STATE OF MAINE
 DEPARTMENT OF TRANSPORTATION
 16 STATE HOUSE STATION
 AUGUSTA, MAINE 04333-0016

February 6, 2023
 Subject: Acadia Gateway
 State WIN: 017163.03
 Location: Trenton
 Amendment No. 9

Please make the following changes to the Bid Documents:

1 WALL SECTION
3/4"=1'-0"

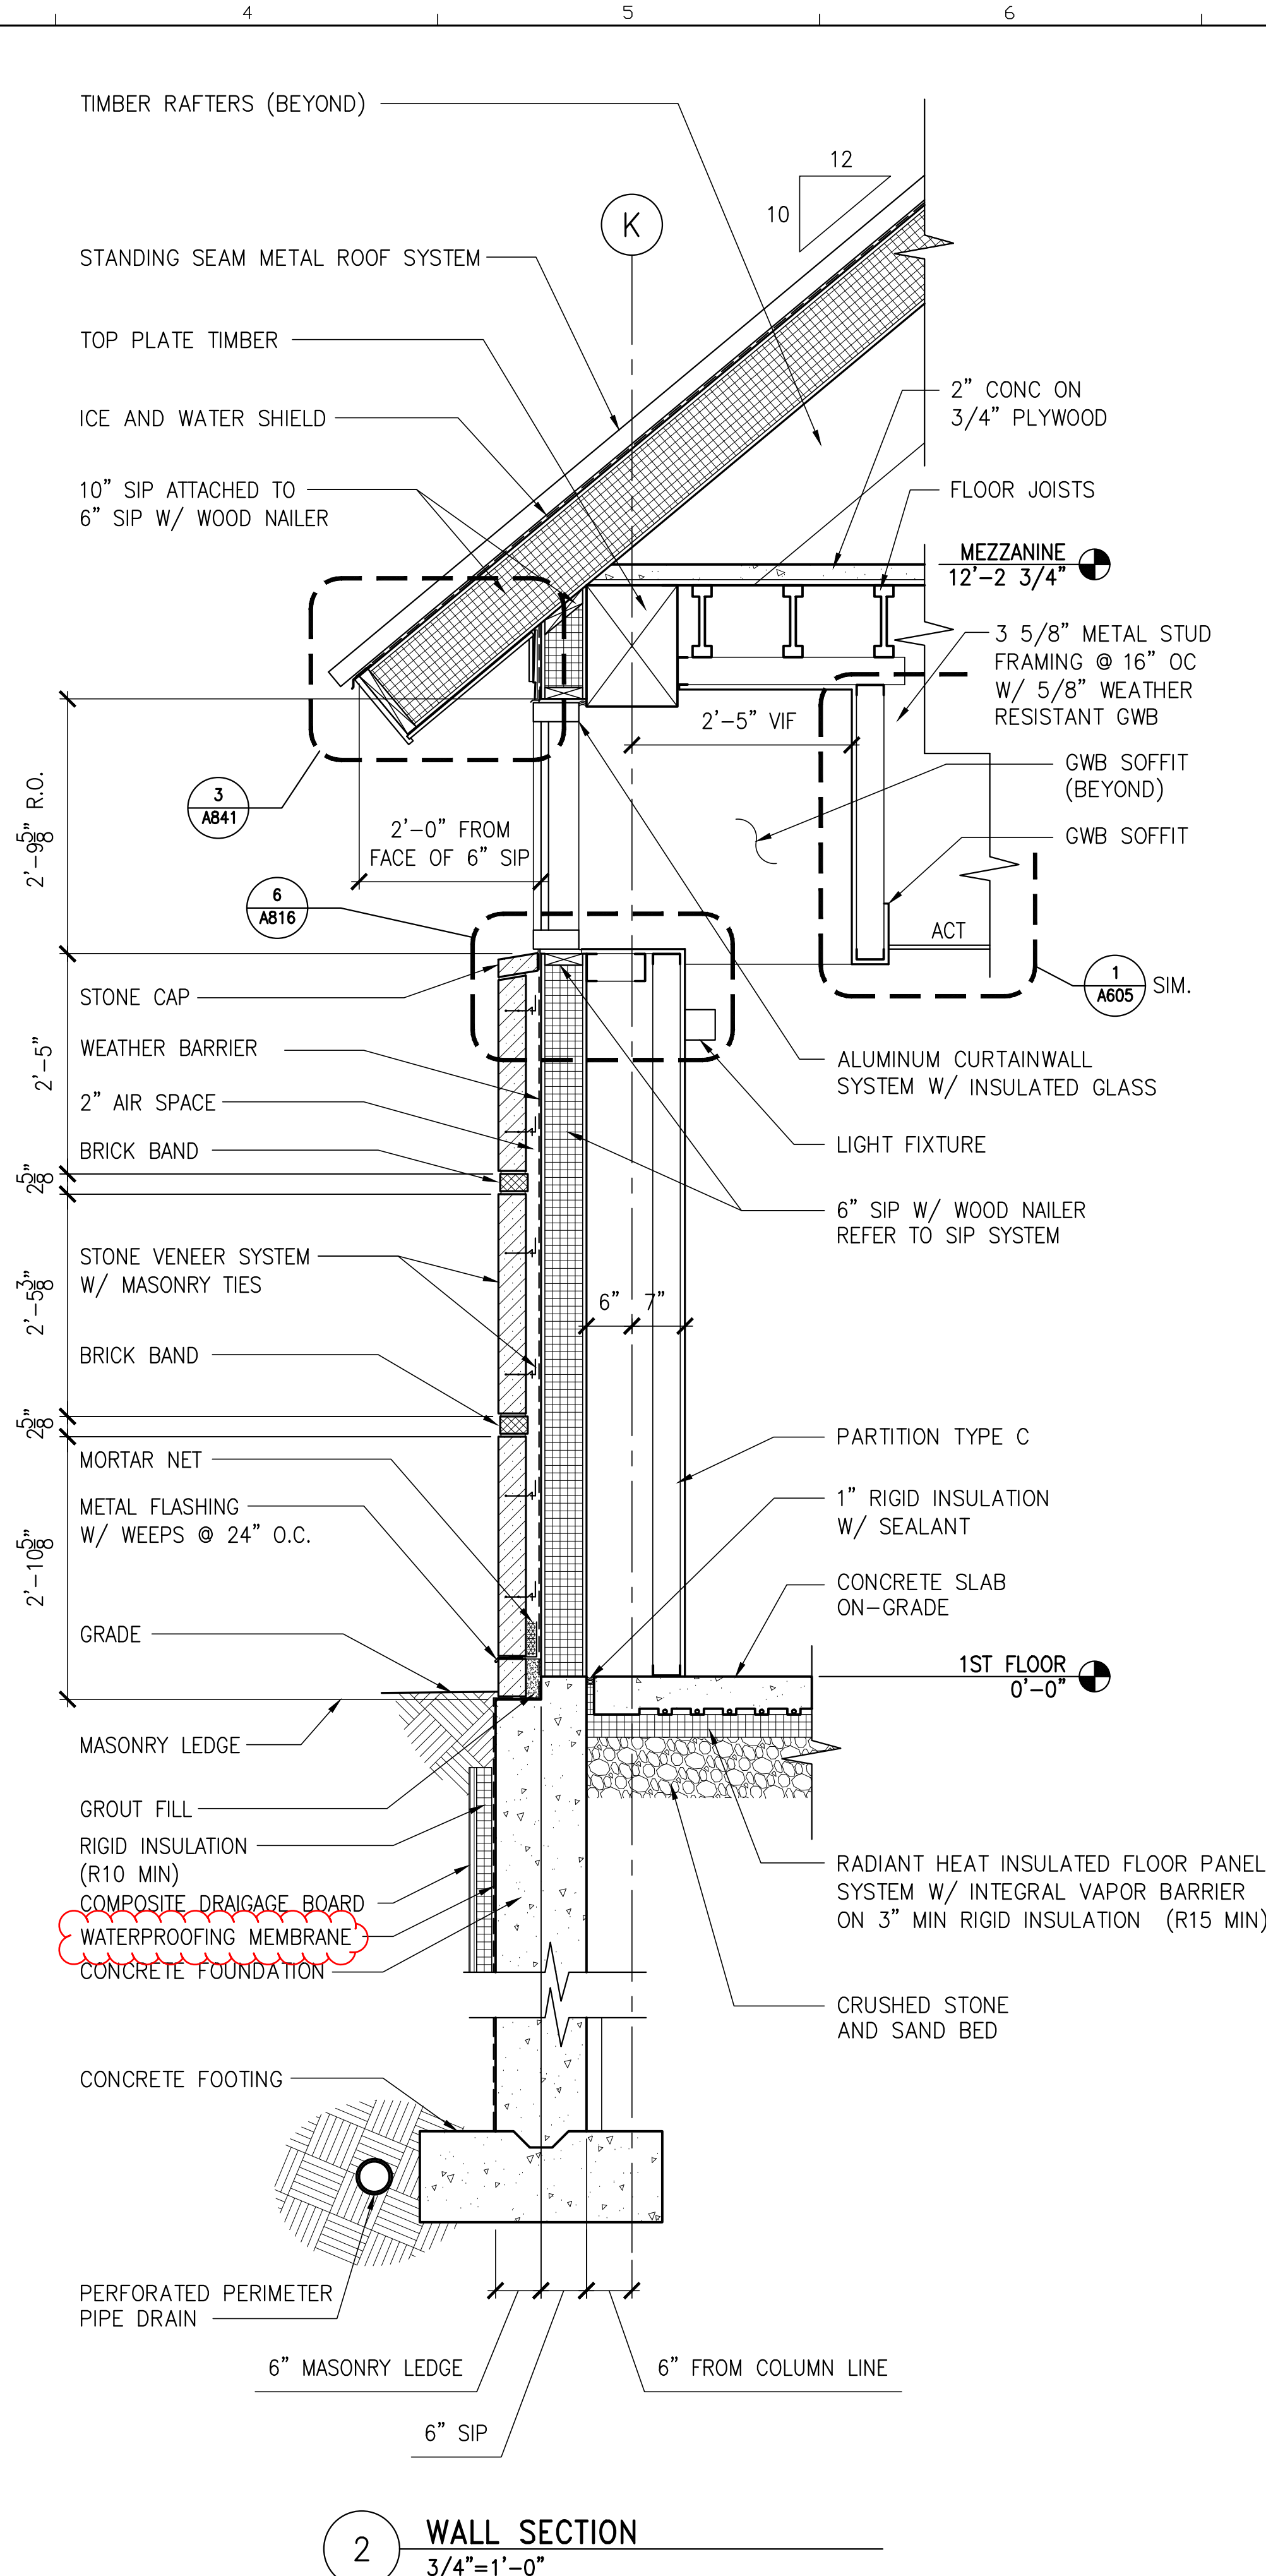
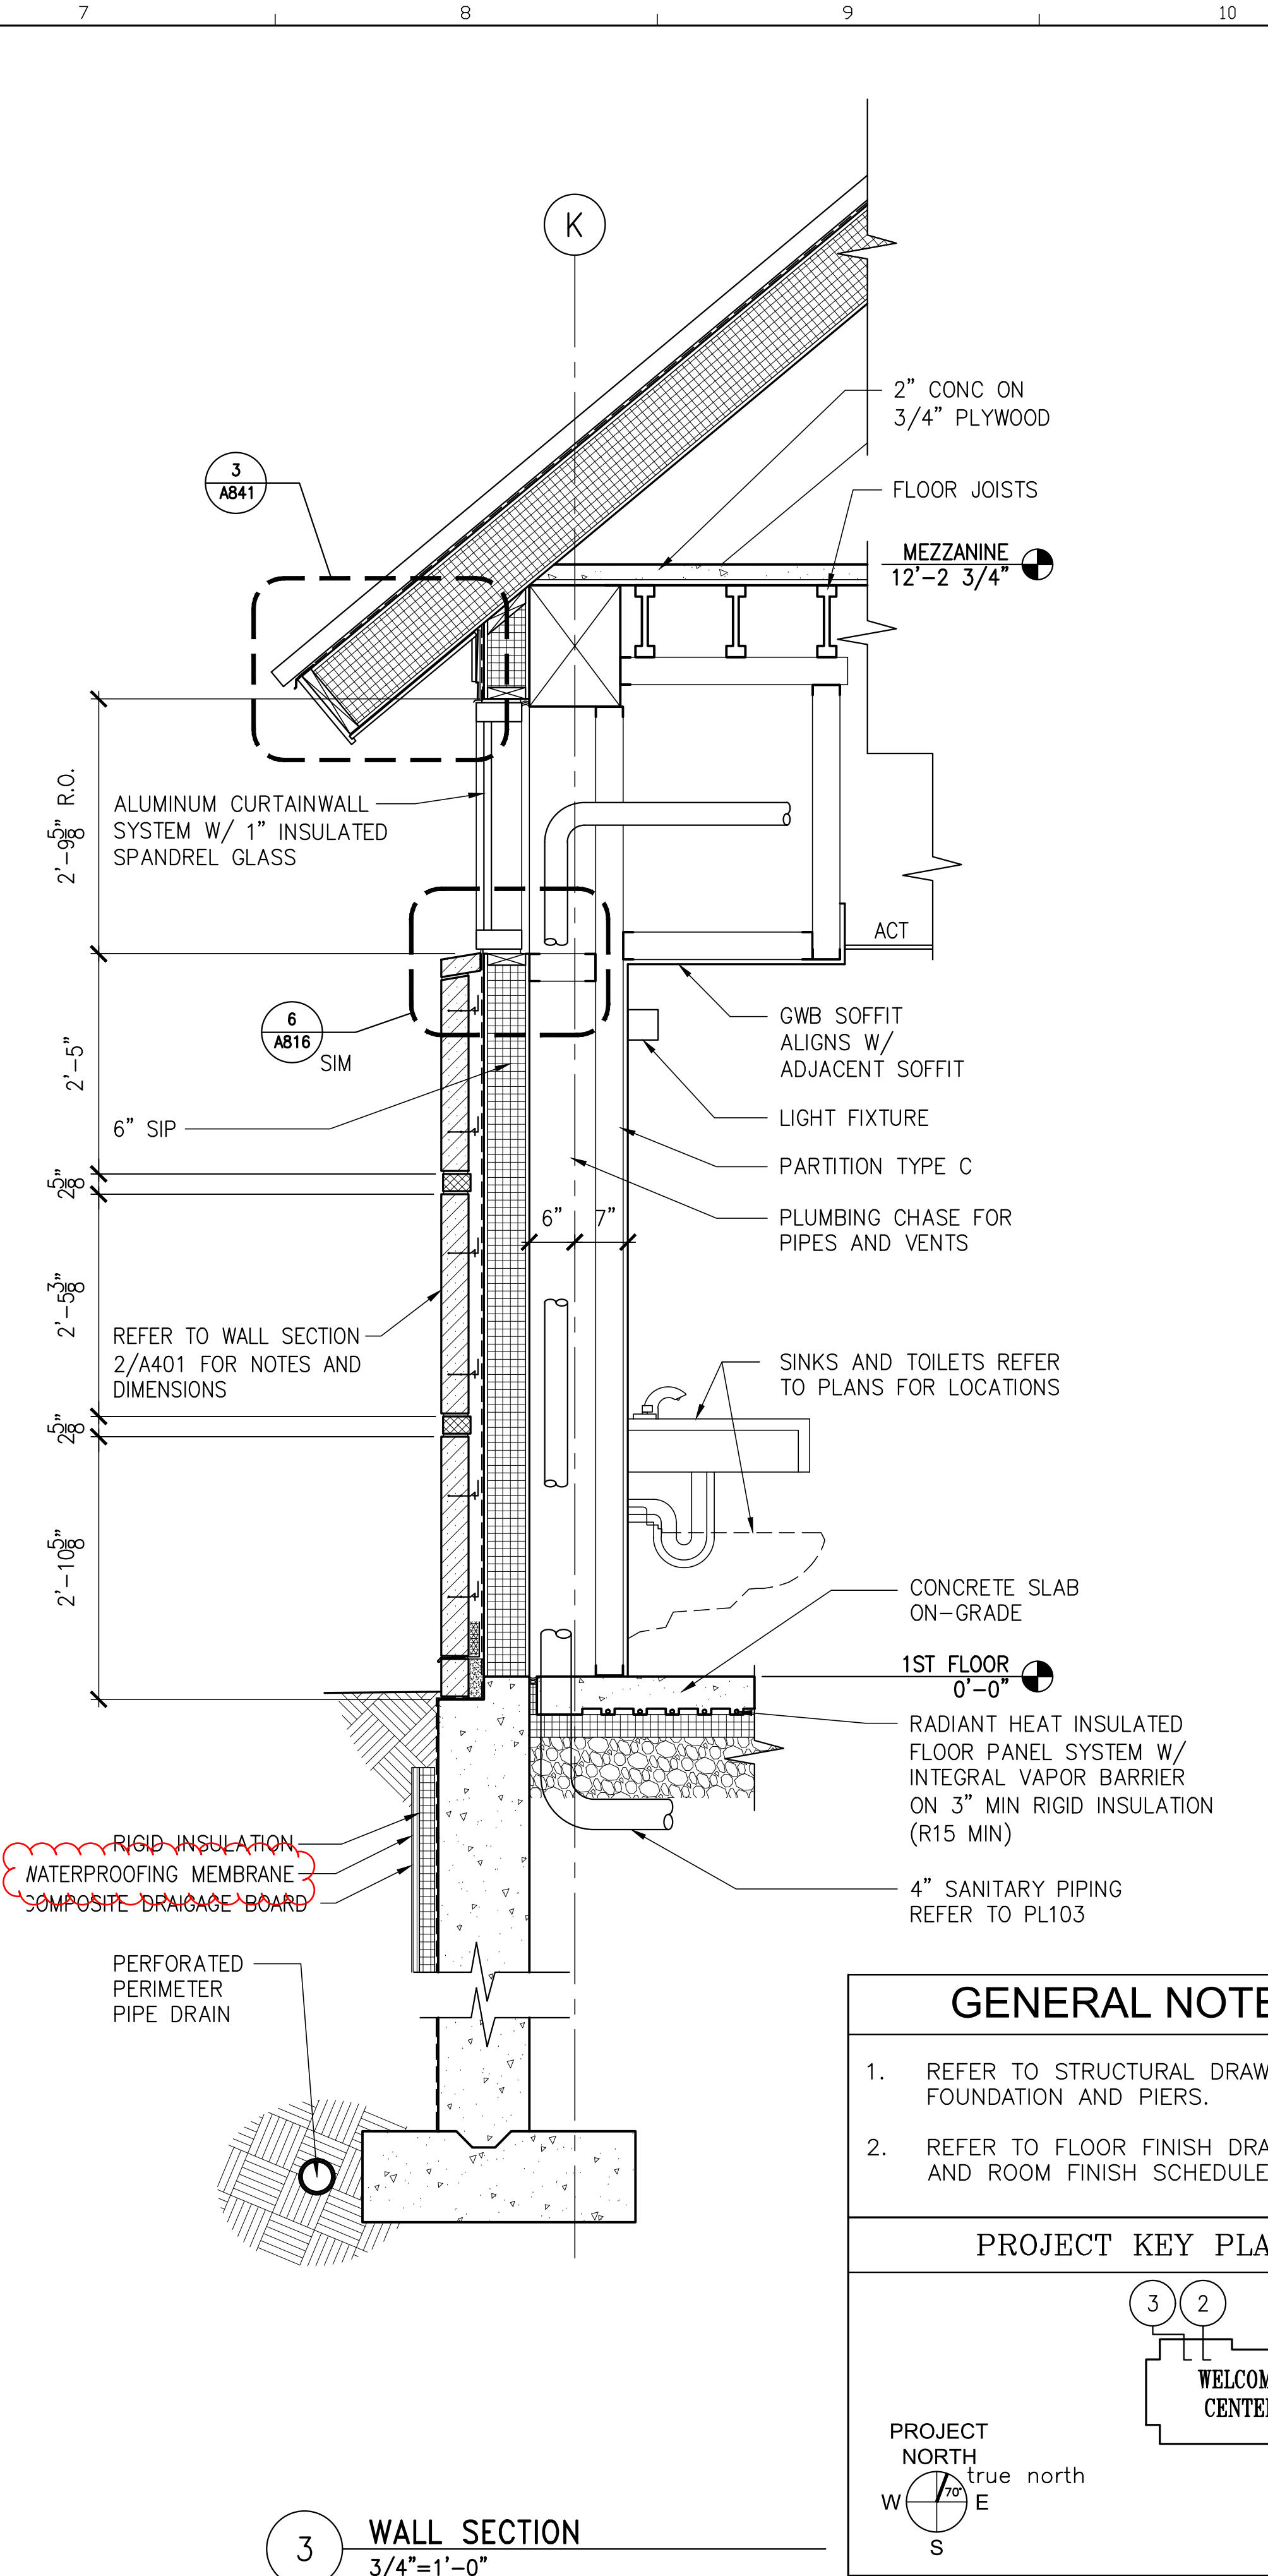
Question: Spec 07416 calls for Procor 75 cold fluid applied for waterproofing and for molded, spec 072726 vapor barrier, indicated foundation and walls (p1.4, c, 1) also a fluid applied material, drawings A401-405 indicates a bituminous damp proofing on frost walls and waterproof membranes on basement walls with board insulation and composite drainage board. Please confirm what product/ spec applies to the labeled waterproof membrane on the basement foundation walls.

AMENDMENT #8 UPDATES:
- CLARIFY WATERPROOFING
MEMBRANE EXTENTS

Response: Extent of waterproofing membrane has been updated; Basement walls are to receive waterproofing membrane as specified.

8 OFFICE (109)
1/4"=1'-0"

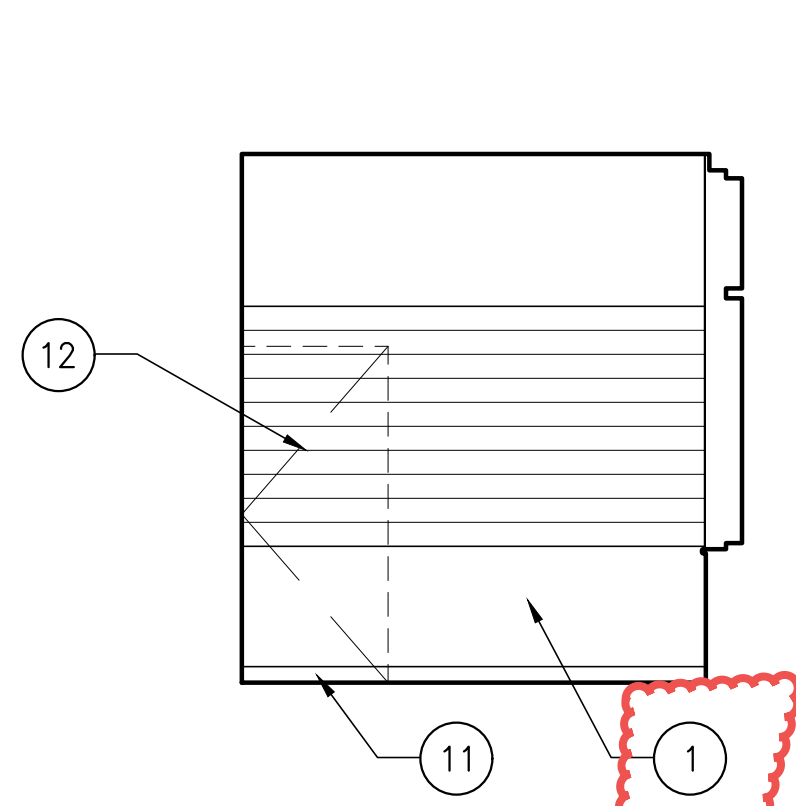
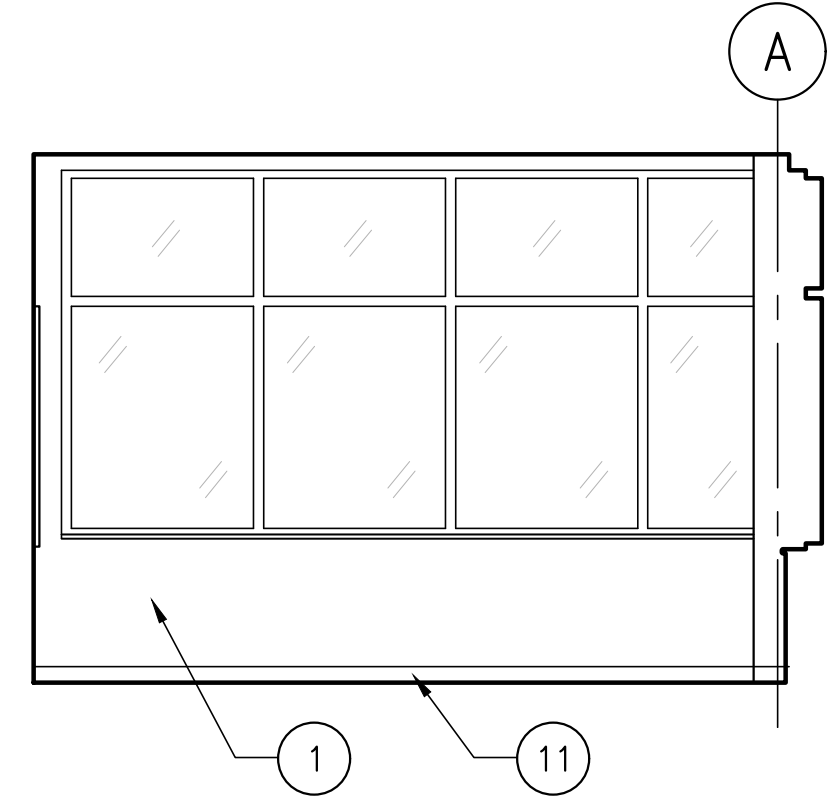
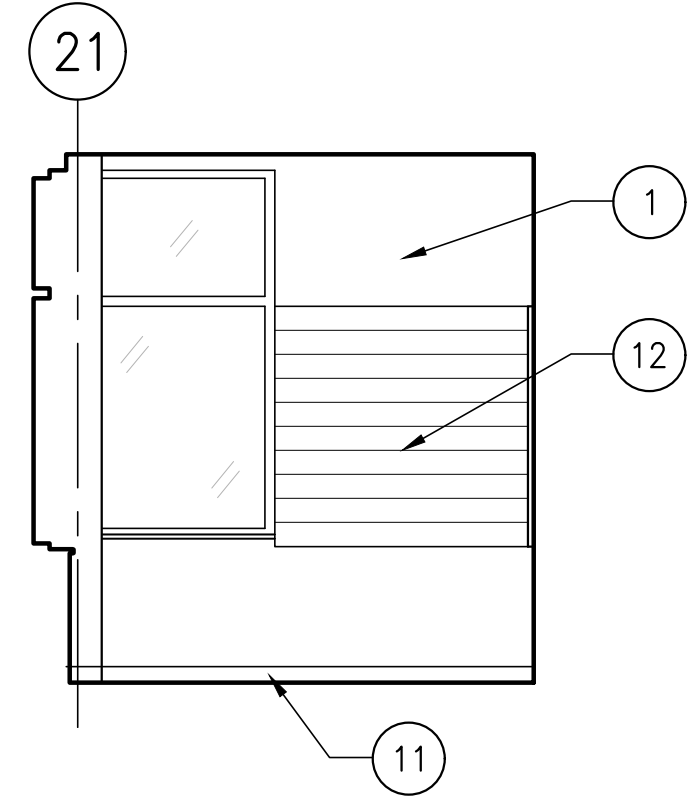
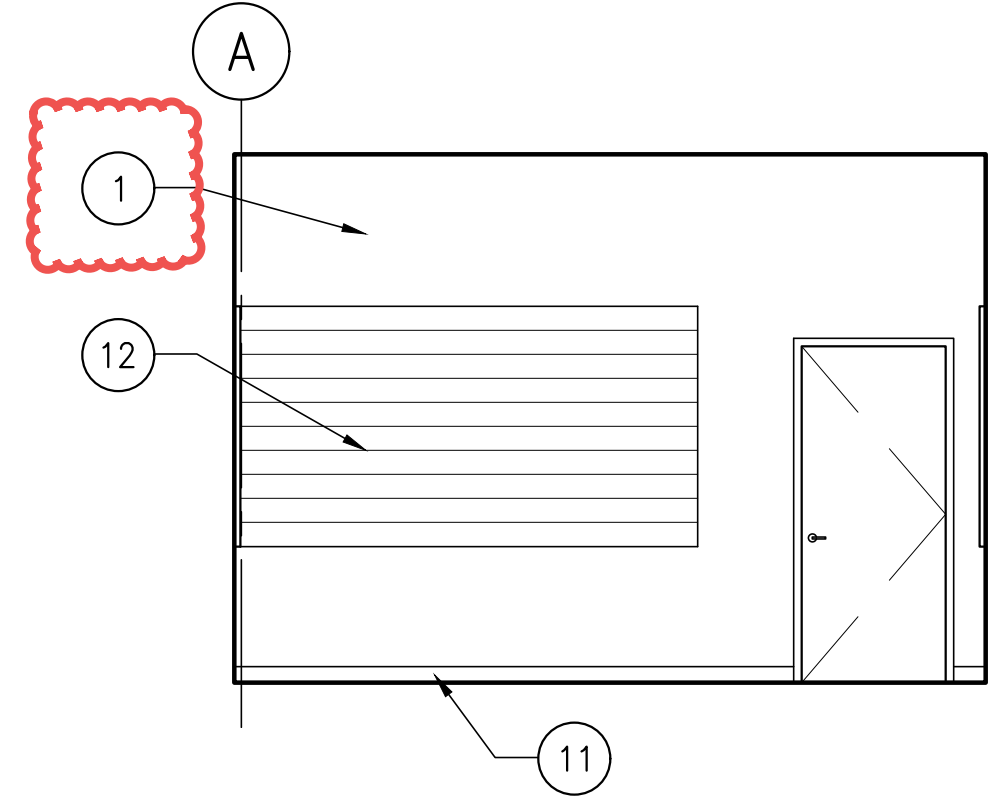
Question: Elevation tags:

- a. A712 (8-11) have a #18 tag for T&G planks
 - i. But yet the elevation does not show (does this room truly get T&G where the #18 tag is?)
 - ii. All other pages have the #18 tag as Acoustic wood-look panels (yet the cut section details show T&G)
 - iii. Please supply brand/make/model for acoustic wood-look panels

Response: Office 109 should have painted gyp walls with slat wall, no wood planks or acoustic wood looks panels. A712 has been updated in Amendment 9.
